Access Compliance Report Public Rights-of-Way (Curb Ramps)

Main Street: DONNIS_RD Cross Street: QUAIL_RUN_RD Location: SW

ADA ID: RPRK220217190245 Ramp Type: Type 1 - Perpendicular Diagonal Initial Pass/Fail: Pass Overall Compliance: No Severity Score: 18

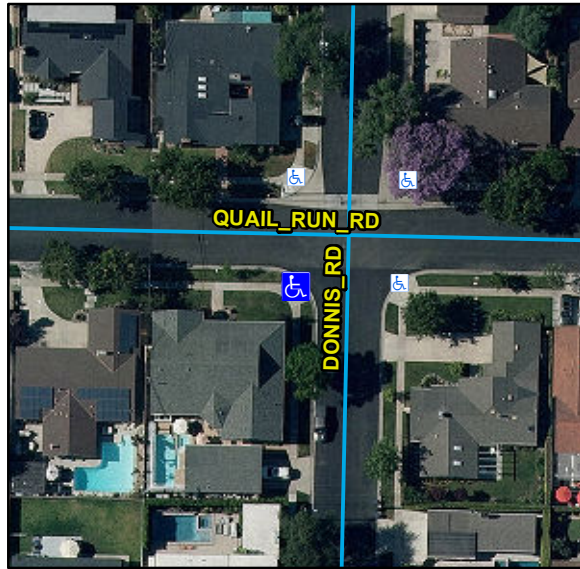
Remove & Replace Curb Ramp With Two New Directional Ramps or Equivalent.

R204.3, R304.2.1, R304.2.2-Perp, R304.3.2-Para, R305, STD 1115
